Dublin Cycling Campaign,
% Tailor's Hall,
Back Lane,
Dublin 8

KELLYSTOWN SHD 308695

13th December 2020

Image 1 : Taken from 15038 P119A Kellystown Link road

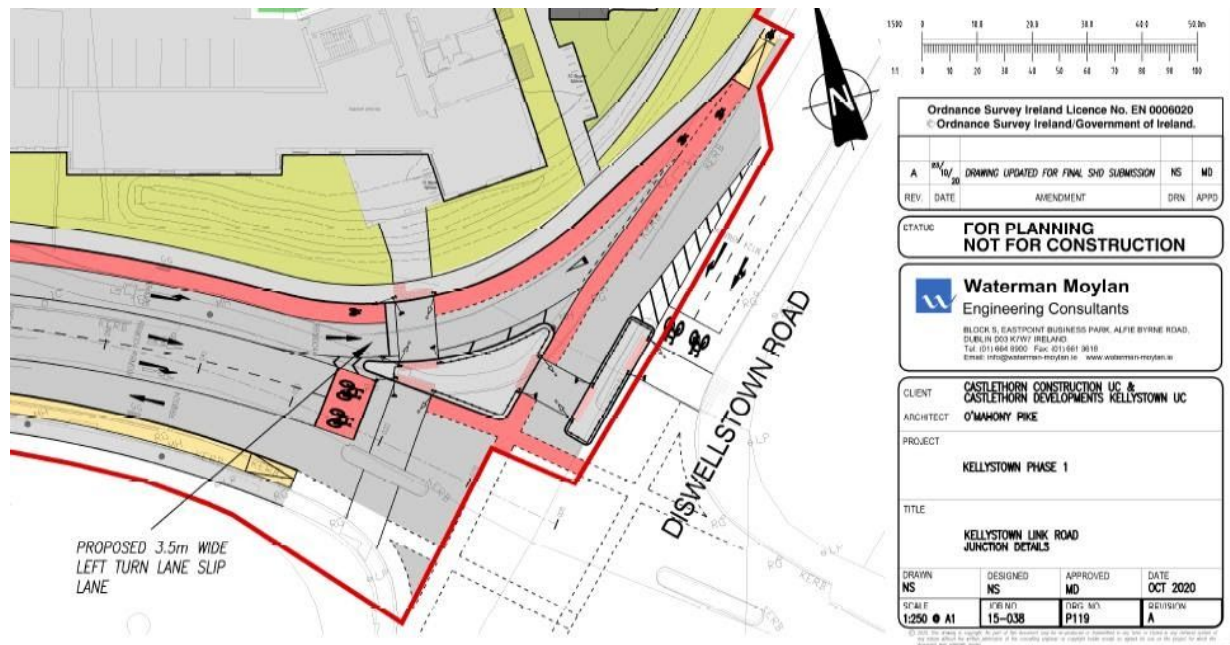
The slip road as shown in Image 1 is taken from the Engineering section of drawings **15038 P119A** as part of the proposed development located at the junction of Porterstown road, Diswellstown road and Dr Troy bridge. There are a number of reason why slip roads are no longer considered best practice

- It would enable and encourage greater vehicle speed movements which are no longer considered best practice by the National Transport authority and are not referenced in the Design Manual for Urban Roads and Streets (DMURS).
- This location is situated beside 3 schools and is very busy with pedestrian and cycle movements in the mornings and evenings before and after school. This will increase the risk of death and injury to Vulnerable Road Users (VRU's) like pedestrians and cyclists.
- The designs do not reflect what Fingal County Council have put out to public consultation in November 2020 as shown in Image 2 taken from the councils consultation portal.

This slip road design is not a design practice in DMURS or the NCM and is contradictory to Objectives 7.1 and 7.21 mentioned above.

Image 3: Junction 4- Upgraded layout. Taken from Traffic and Transport assessment on Page 53

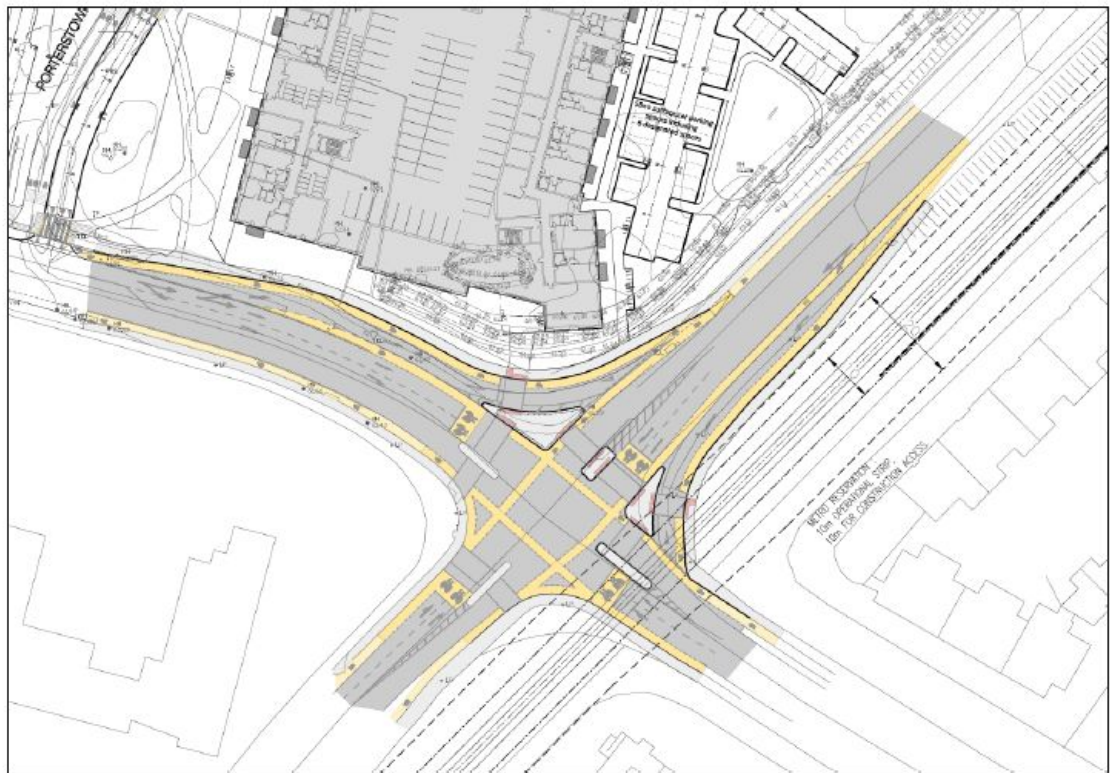
- As shown in Image 3 taken from the Traffic and Transport assessment from pages 52 and 53, the developers have mentioned that there are extra left turning lanes proposed in the current development plan by Fingal County Council for the Kellystown road upgrade. They are correct that there are proposed extra left turning lanes but they do not feature slip roads with a stand alone left turning lane and concrete islands increasing crossing times for pedestrians and cyclists. Image 2 shows what the council has proposed. The image shown by the developers fails to meet the standards and guidelines detailed in the Fingal County Council development plan, DMURS, National Cycle Manual and the National Transport Authority. Text taken from report:

- On pages 52 and 53 of the Traffic and Transport assessment the developers put forward an argument for increased traffic movements to facilitate increased vehicle movements.

They have failed to mention the planned Dart+ West upgrade, at an advanced planning stage, that is currently underway and modal shift with Fingal County Council providing better cycling and walking infrastructure to get people out of their cars. In light of COVID-19 work patterns will have changed since the designs with most people having some form of working from home practice built into their week in a post COVID-19 scenario.

Image 7: Taken from 1506A-OMP-BA-00-DR-A-1000_BlockA_Level00

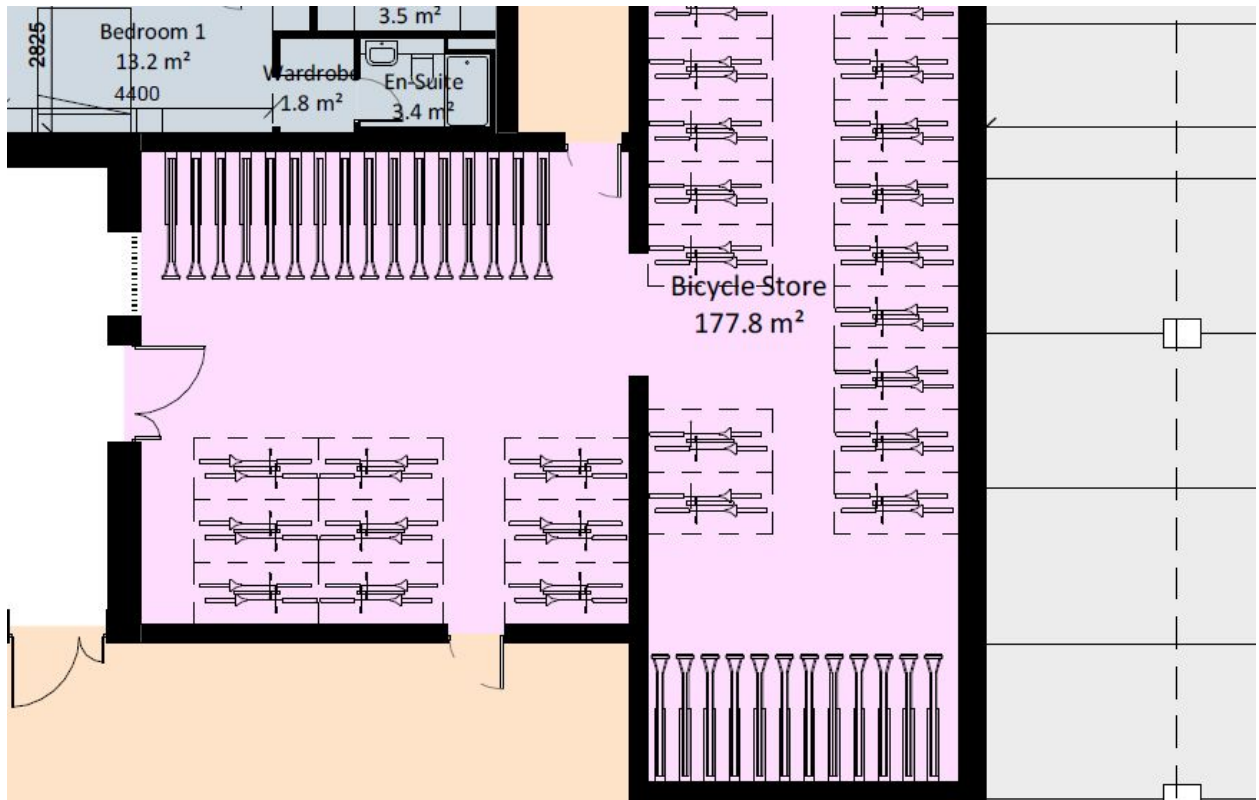
From the designs of the ground floor bicycle parking in Block A it is shown in document **1506A-OMP-BA-00-DR-A-1000_BlockA_Level00** and Image 7 below. it is unclear if the two tier style parking is gas assisted as recommended in the guidance document from Dublin Cycling Campaign referenced in the Sustainable Urban Housing: Design Standards for New Apartments 2018. In Image 7 the two tier parking stands can be difficult to use for some people if they have to lift the weight of the bike above head height without a gas assisted device connected to the bike rack.

Are the visitor bicycle parking spaces protected against the weather? It is not clear from the designs if they are.
